CITY of NOVI CITY COUNCIL

SUBJECT: Consideration of the request of Novi Town Center Investors, LLC, for the approval of the Preliminary Site Plan SP 10-26 and Section 9 façade waiver. The subject property is located east of Novi Road, north of Grand River Avenue, in the TC, Town Center District. The applicant is proposing to demolish Building F and construct a parking lot and associated landscaping in its place.

Novi Town Center Building F Demo SP 10-26

Novi Town Center Bldg. F Demo

PAVING AND GRADING PLAN

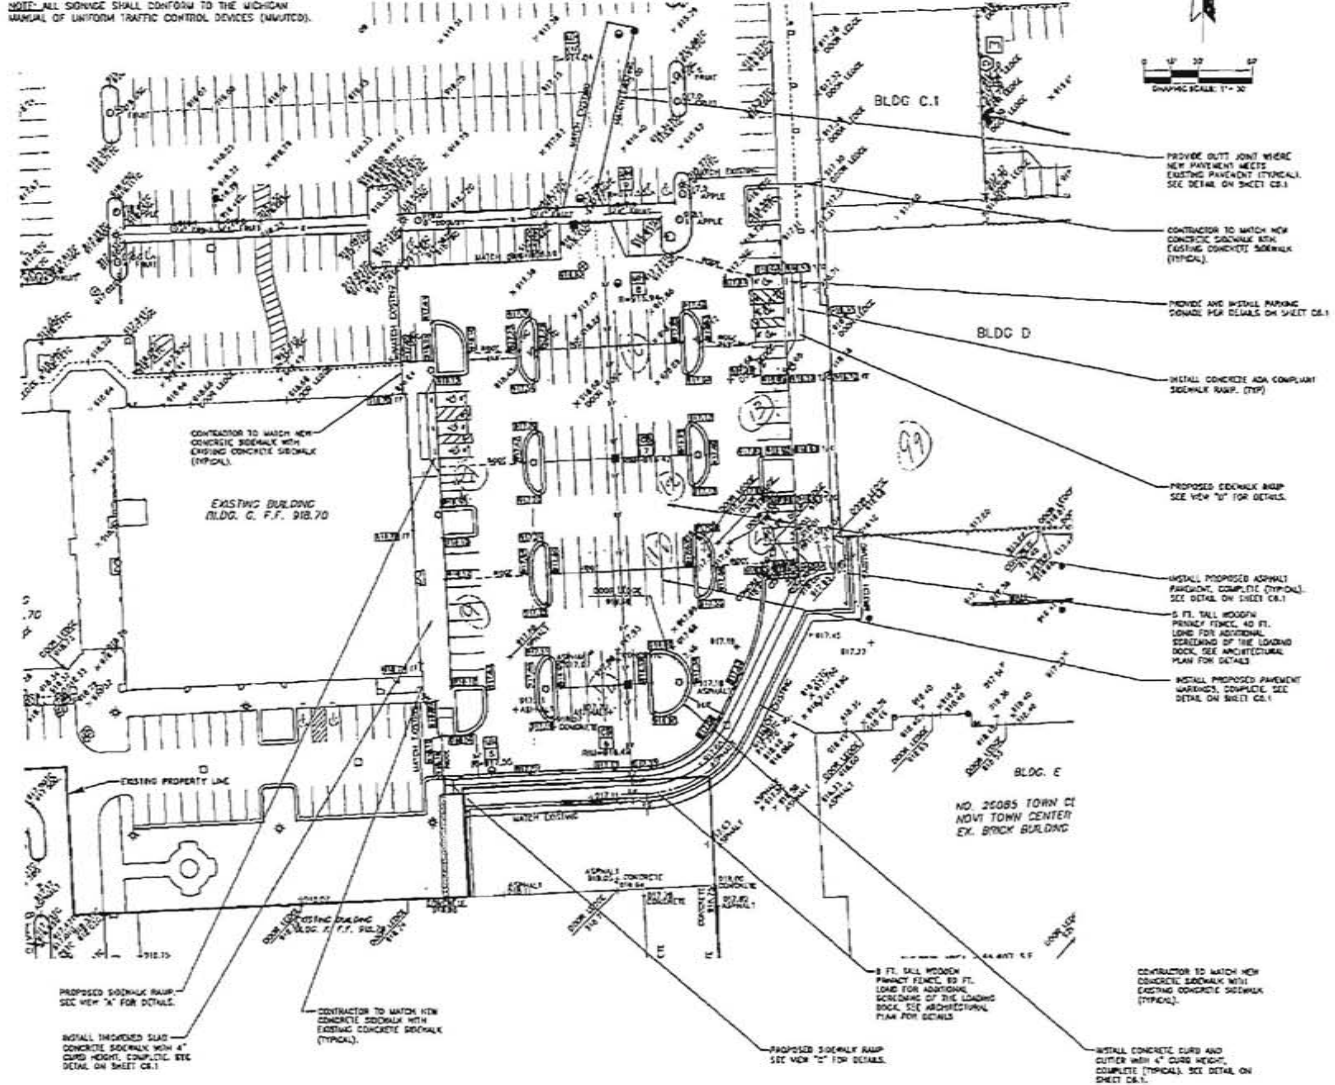
8. Relocated manhole 8 further south and west to maintain a minimum 10-foot horizontal clearance between the outside diameter of the manhole and the existing water main or gate well.
9. The profile is labeling the run between MH5 and CB6 as 24-inch RCP at 0.2% and the plan view is labeling it as 12-inch RCP at 0.33%. Please clarify on the plan. 12-inch storm sewer requires a minimum of 0.32% slope.
10. Label the 10-year HGL on the storm sewer profiles, and ensure the HGL remains at least 1-foot below the rim of each structure.
11. Provide a schedule listing the casting type and other relevant information for each proposed storm structure on the utility plan. Round castings shall be provided on all catch basins except curb inlet structures.

14. Verify the slopes along the ingress/egress routing to the building from the barrier-free stalls comply with Michigan Barrier-Free regulations.
15. Provide top of curb/walk and pavement/gutter grades to indicate height of curb adjacent to parking stalls or drive areas.

16. Curbing and walks adjacent to the end of 17-foot stalls shall be reduced to 4-inches high, rather than the standard 6-inch height to be provided adjacent to 19-foot stalls. Provide additional details as appropriate and label all curbing heights on the plan.

7. We will resubmit a revised set of plans via email prior to our stamping set submittal.
8. We will revise the location of Manhole 8 to maintain 10 ft. horizontal clearance with the water facility.

9. The profile label includes an error, we will revise this to show that it is indeed a 12" RCP with 0.32% slope, per City Standards.
10. We will indicate the 10 yr HGL in our storm profiles.

15. Top of Curb / Top of walk grades will be added.
16. All curbs adjacent to head in parking are 4" curb, plans will be revised as per above comment.
17. A letter will be prepared and submitted with the revised plans outlining all changes. A statement will be included that all changes to the plans have been identified in said letter.

PROPOSED EAST ELEVATION
SCALE 1/8" = 1'-0"

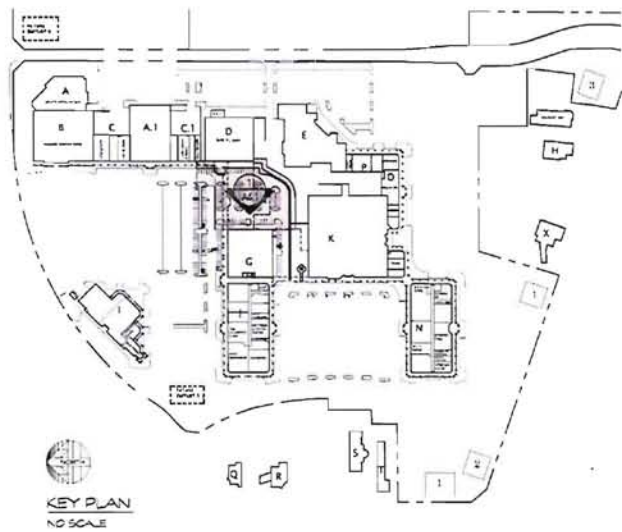
As shown above the proposed materials are in full compliance with the Façade chart, with the exception of Section 2520, Footnote 3, which states that Standing Seam Metal must be "100 percent copper or copper bearing paint in the TC and TC-1 districts."

With respect to the use of non-copper colored standing seam metal awnings, the proposed design is consistent with other recent facade upgrades for which the Planning Commission has previously granted Section 9 waivers for the use of green, blue and black standing seam metal. The proposed design is in full compliance with Section 1602.9 of the Ordinance which requires that materials used in the TC and TC-1 districts be "primarily brick or stone".

- Item No. 4: The Section 9 waiver will be requested for the metal awning color, as has been requested and granted on previous Phases of the Shopping Center upgrades and remodeling.
- Item No. 6: The lamp type for the Sun Valley light fixture will be a 70-watt metal halide as specified on Sheet SE0.2 of the Site Plan Submittal.

- The Section 9 waiver will be requested for the metal awning color, as has been requested and granted on previous Phases of the Shopping Center upgrades and remodeling.
- The screening of the newly exposed service court for Building "E" and "K" will be discussed and resolved at the June 23rd Planning Commission Meeting.
